# ADDENDUM No. 1

RFP No. 22-20

## 2022 Miscellaneous Utility Projects

Plan Sheets                            Replace Plan Sheets 4, 7 and 11.

**CITY OF ANN ARBOR - PUBLIC SERVICES - ENGINEERING**  
2022 MISC UTILITY PROJECTS  
TYPICAL ROAD SECTIONS  
ROAD CROSS-SECTIONS - DICKEN DRIVE

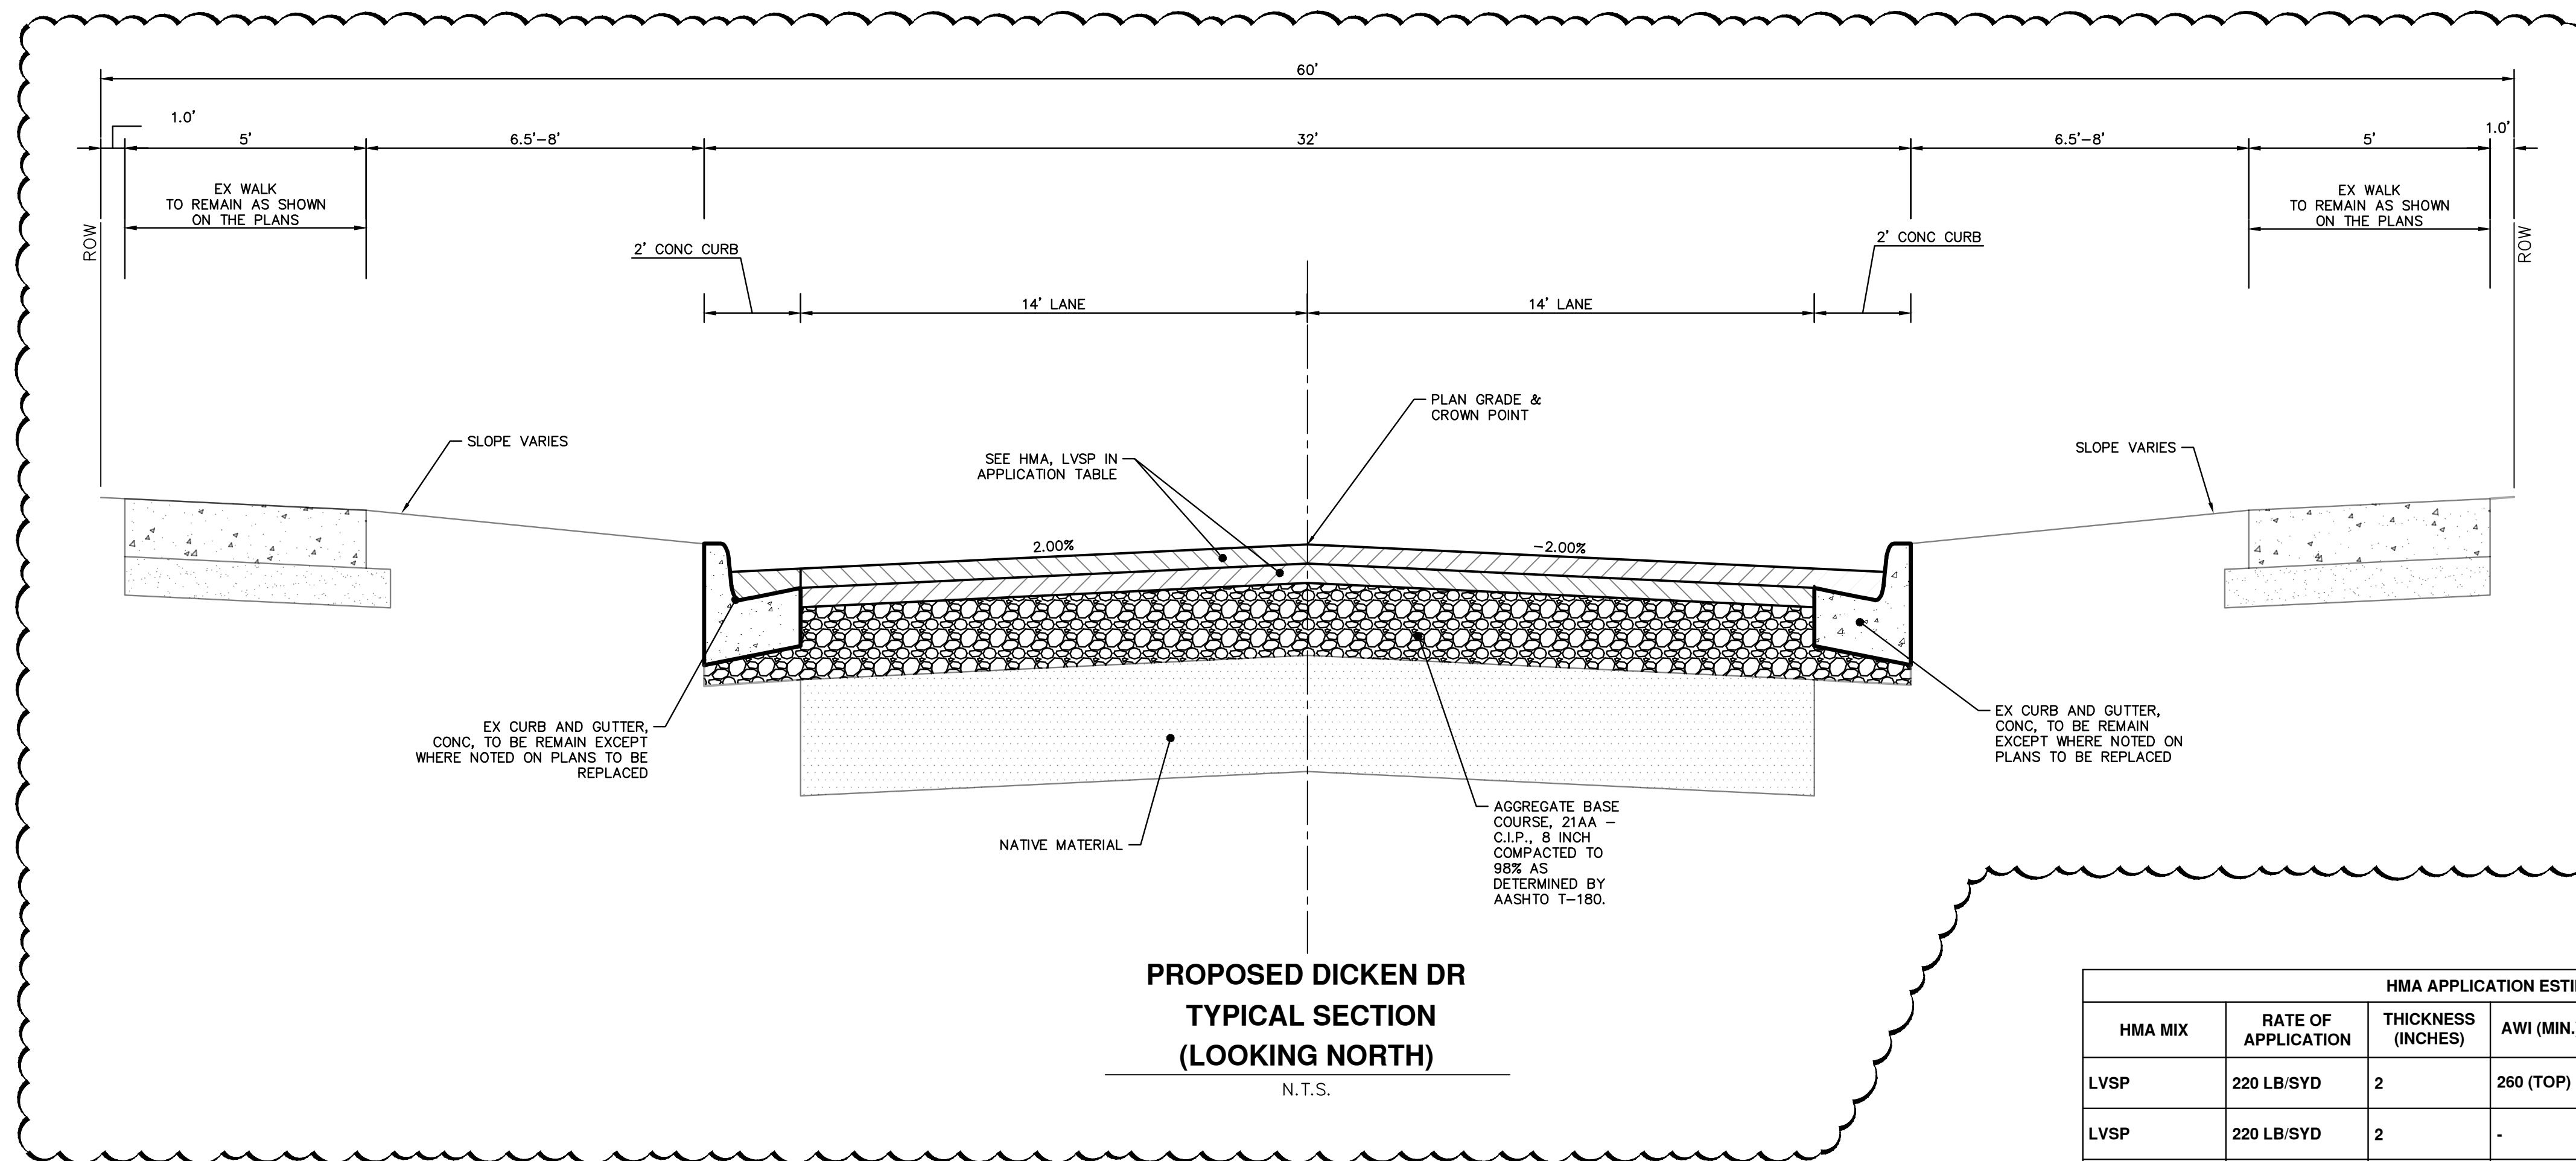
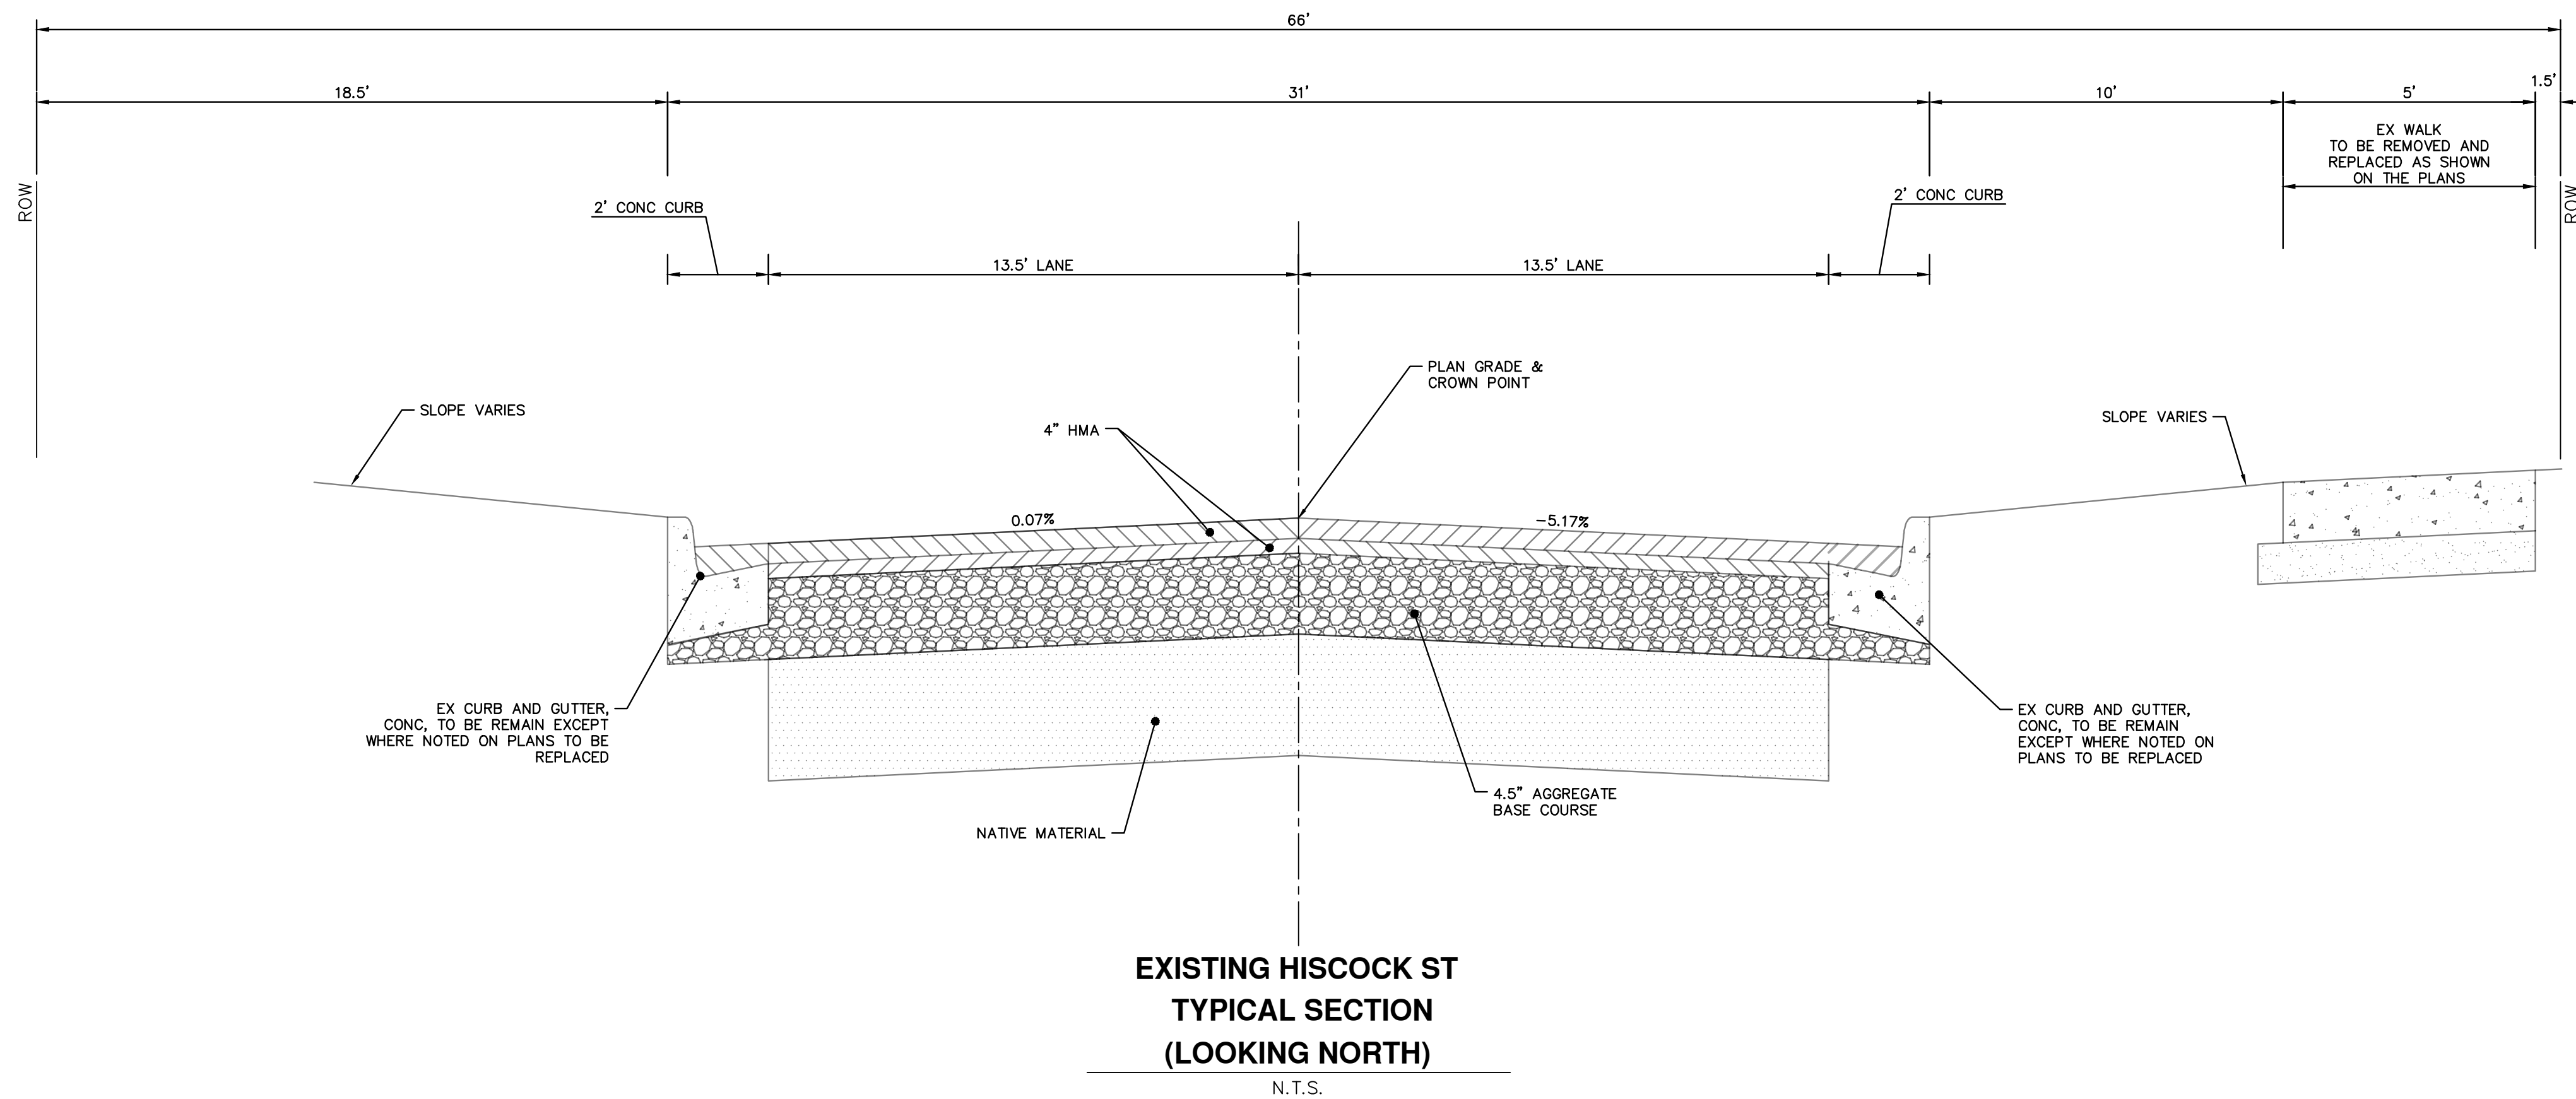
*Comment: Updated road cross sections for Dicken and Hiscock. Added Split Rail Fence Detail.*

Question 7:    On the proposed cross section for Dicken Drive and Hiscock Street you show sand subbase but do not call out the depth. What is the depth for the sand subbase?

*Answer 7:    Detail has been revised per attached drawing to clarify subbase.*
